Cross River Rail Project

Coordinator-General's change report — Temporary Roma Street Coach Terminal

August 2018

Figure 3.1 Site of proposed temporary Roma Street coach terminal (Source: June 2018 project change application)

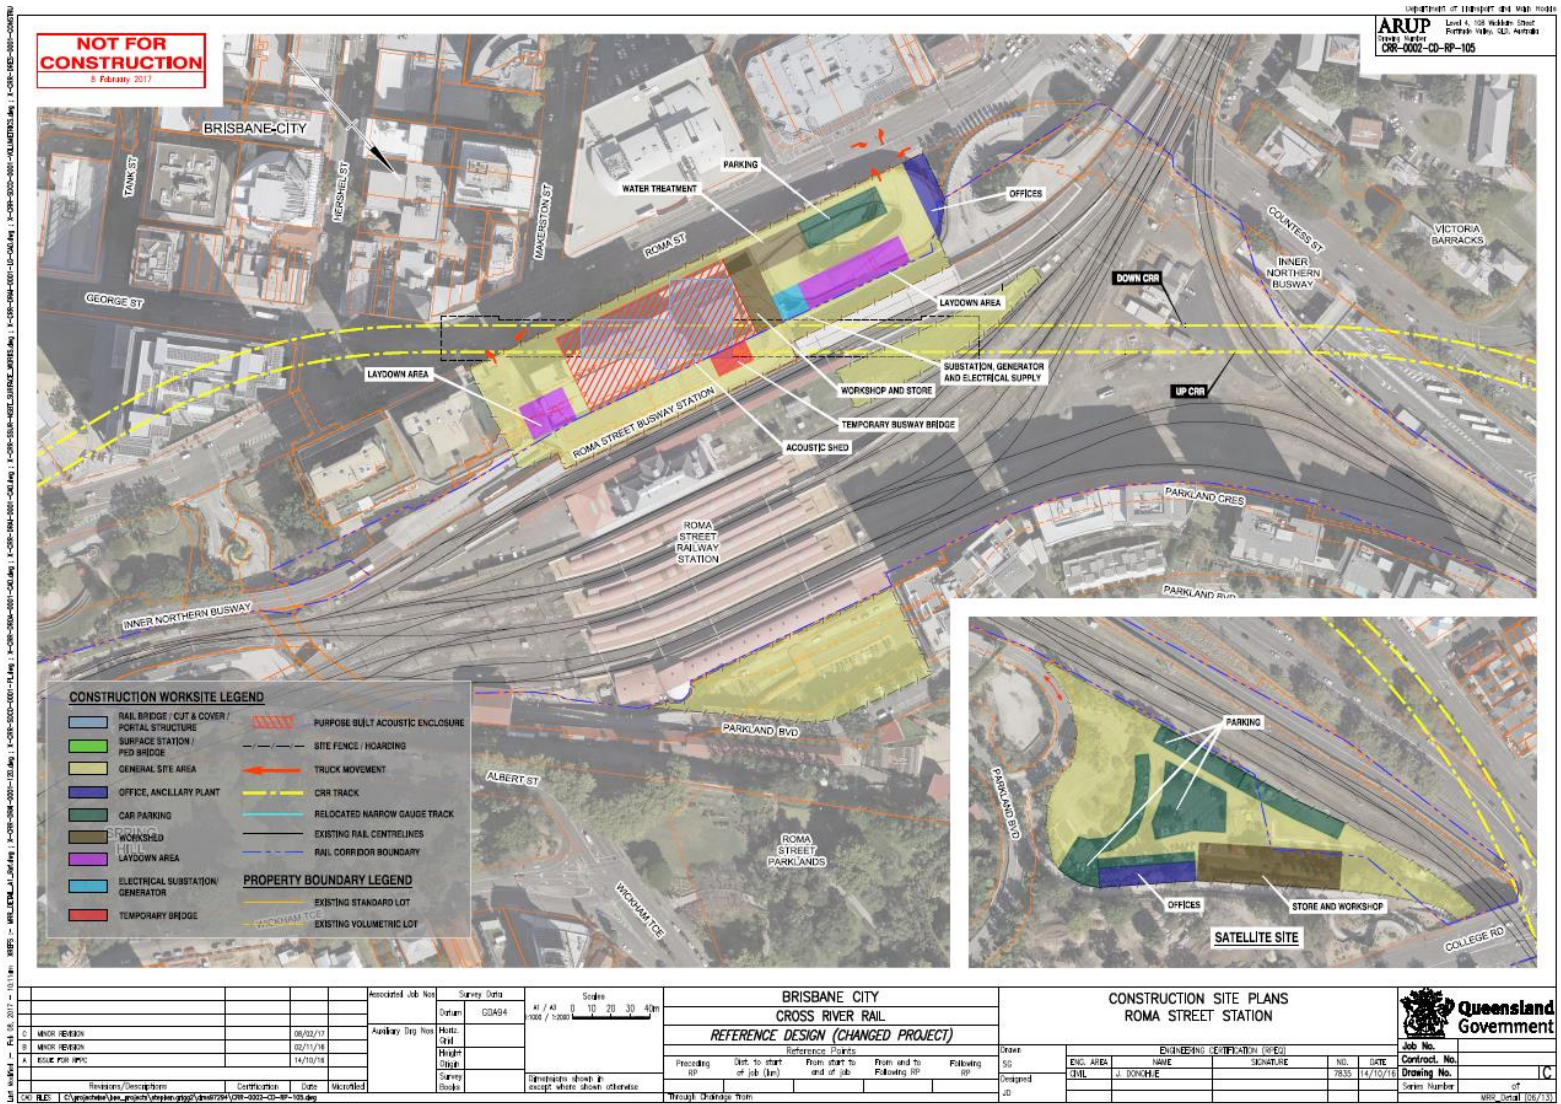
In the June 2018 project change application, the proponent proposes to temporarily relocate the Roma Street long-distance coach terminal to an area adjacent to Roma Street Station Platform 10 currently used as a carpark and drop off area (Figure 3.1). The area was previously identified and approved for use as a general construction site area (for construction storage and laydown) for the project in the June 2017 CGCR (Figure 3.2).

The site identified for the temporary coach terminal is situated on part of a large freehold lot described as Lot 60 on SP207215. This lot also contains a significant section of the wider Roma Street Parklands precinct (Figure 3.1).

Figure 4.1 Proposed design improvements for the Parkland Boulevard and Parkland Crescent intersection (Source: June 2018 project change application)

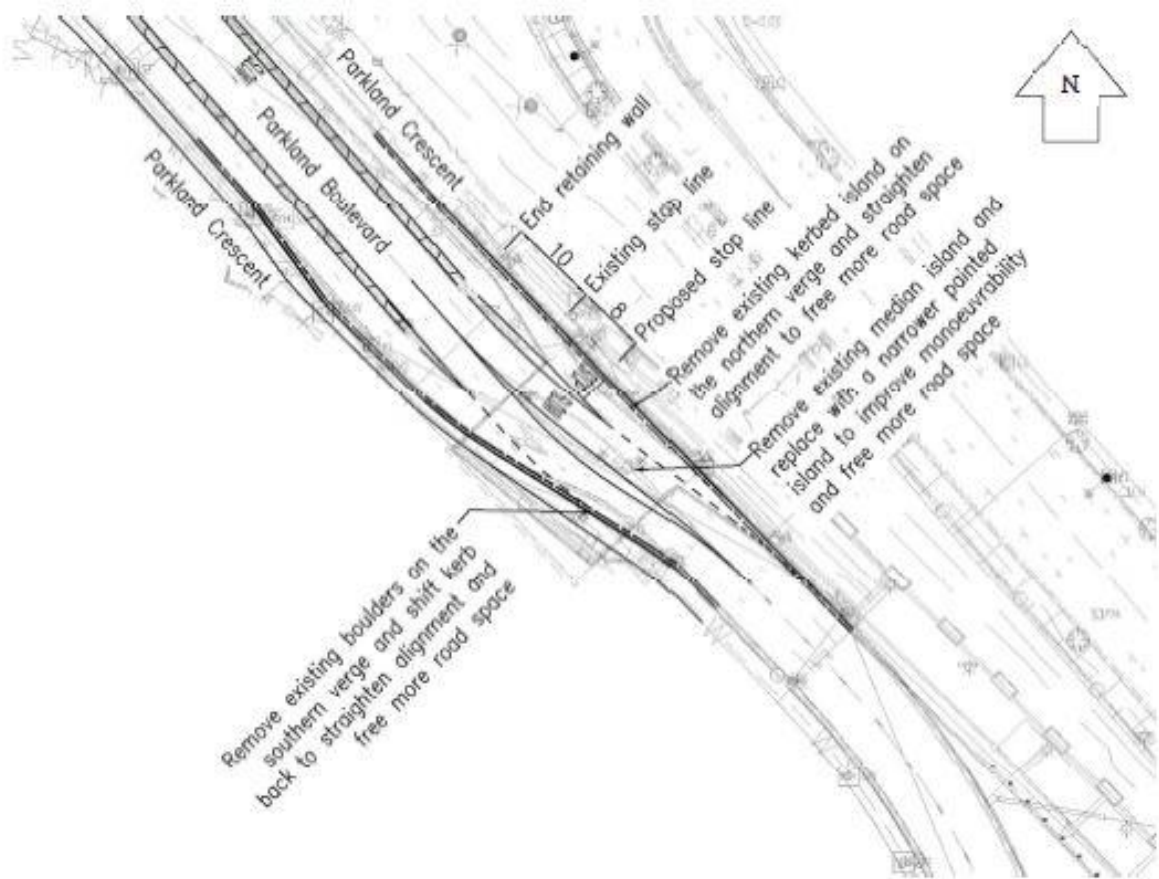
The Parkland Boulevard/Parkland Crescent (south) intersection is currently a priority-controlled (stop sign) intersection with limited sight lines due to the configuration of the ramp and concrete barriers. The volume of vehicles using this intersection is anticipated to increase upon operation of the temporary coach terminal which may lead to an increased risk of conflict between cyclists and traffic. In recognition of these concerns I have imposed a condition which requires the proponent to undertake the following design improvements (Figure 4.1) of the intersection in consultation with BCC:

- move the existing stop line forward approximately 8 metres to improve vehicle visibility
- remove existing kerbed island on the northern verges and boulders on the southern verge to create more road space and straighten the alignment of the intersection.
- remove the existing median island and replace with a narrower painted island to create more road space which will improve manoeuvrability.
